DESCRIPTION: Ltr re our 6-13-75....trans the following: <u>DIST PER LA WILSON</u>	ENCLOSURES: Info concerning secondary system fluid flow instability in the Diablo Canyon design.... (15 cys encl rec'd)
PLANT NAME: Diablo Canyon 1 & 2

Diablo Canyon Units 1 and 2

Secondary System Fluid Flow Instability

Information Requested By NRC Letter Dated June 13, 1975

UNIT 1
DIABLO CANYON SITE
 PIPING ISOMETRIC DIAGRAM
 AUXILIARY FEEDWATER SUPPLY
 STEAM GENERATORS 1-1 & 1-2

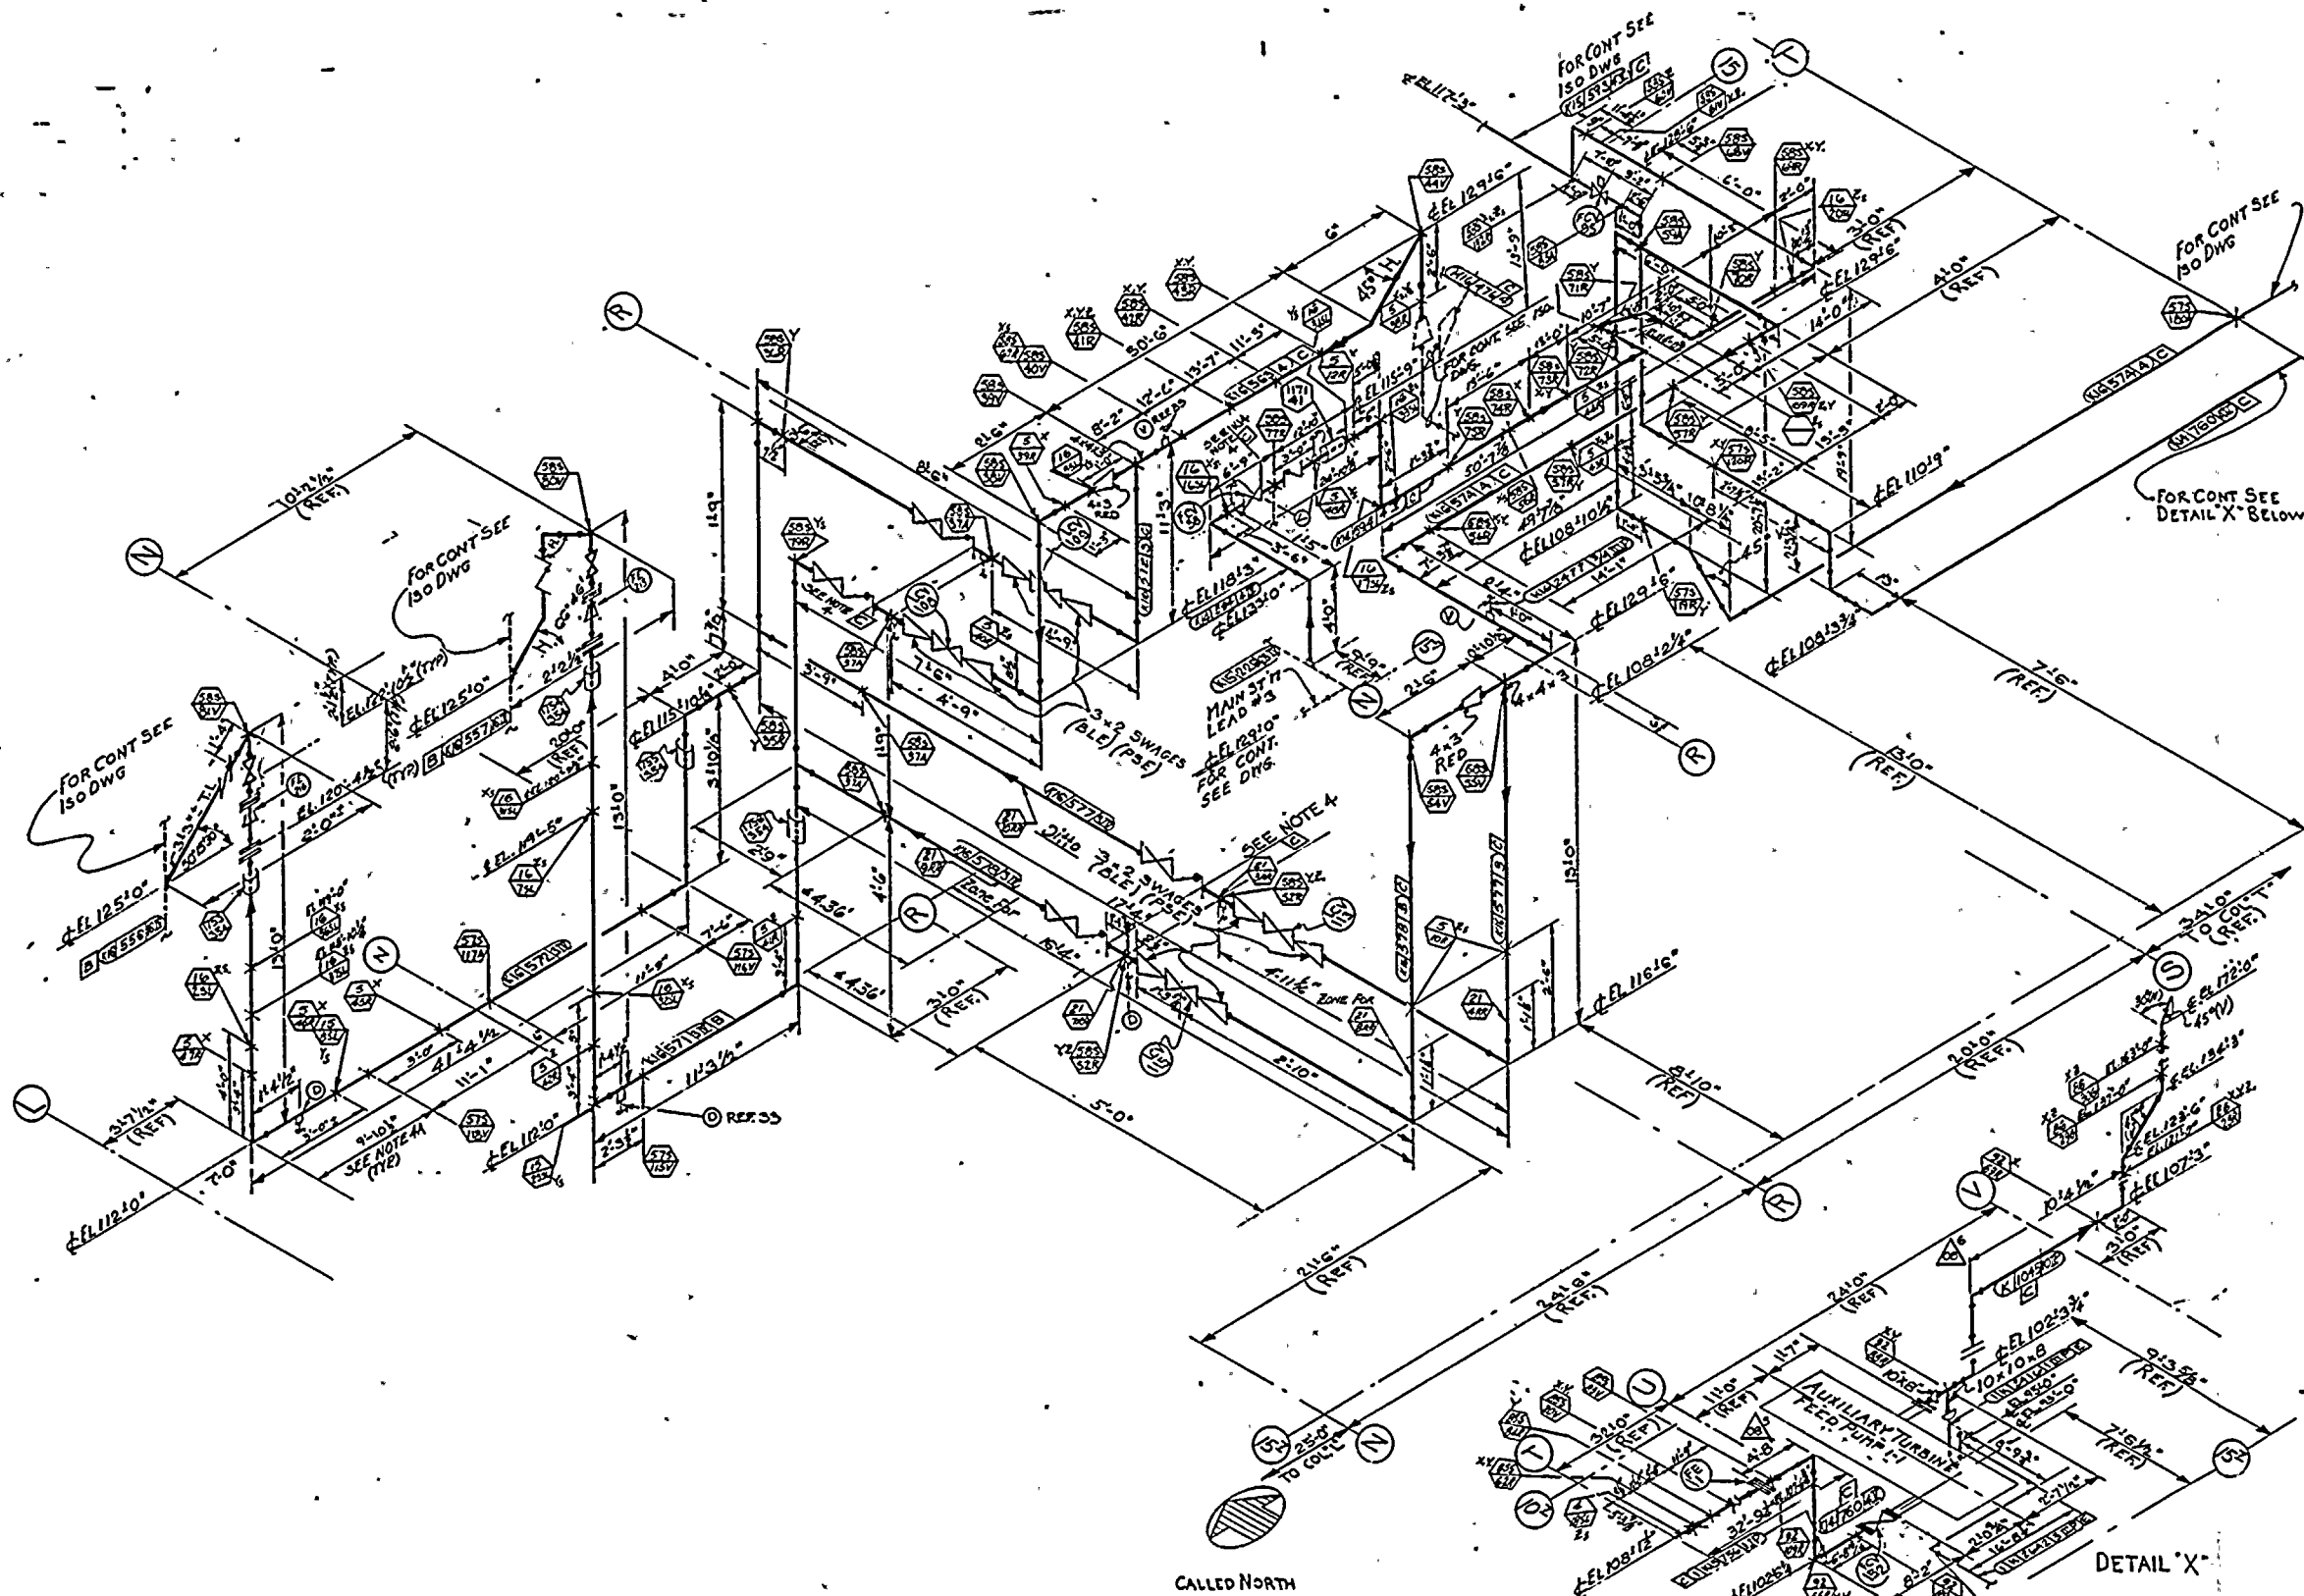
Question 2. Describe and show by isometric diagrams, the routing of the main and auxiliary feedwater piping from the steam generators outwards through containment up to the outer isolation valve and restraint. When describing the piping run, note all valves and reference continually, the elevation of the inlet nozzles and/or sparger with respect to the piping run elevation.

All auxiliary feedwater lines join the respective main feedwater lines outside the containment penetrations, which are anchor points for the steam generator feedwater lines. The Unit 1 steam generator 1-1 auxiliary feedwater line has a 4 foot 3 inch run horizontally from the nozzle on the feedwater line at elevation 129'-0", 25 feet 4 inches below the steam generator feedwater nozzle. It turns 90° in the horizontal plane and runs a further 3 feet 3 inches. This run includes a check valve. The line turns and runs vertically downward to elevation 117'-11", 36 feet 5 inches below the steam generator feedwater nozzle. The line turns from the vertical and runs horizontally 15 feet 5 inches. In this run, there is a manual gate valve which is the isolation valve for this line. Each of the four auxiliary feedwater lines continues, dividing and eventually arriving at a motor driven auxiliary feedwater pump and at the turbine driven auxiliary feedwater pump.

The Unit 1 steam generator 1-2 auxiliary feedwater line has a three foot horizontal run at elevation 129'-0", 25 feet 4 inches below the steam generator nozzles. This run contains a check valve. The line turns 78°-19' in the horizontal plane and runs for an additional 3 feet 6 inches and contains a manual gate valve which is the isolation valve for this line.
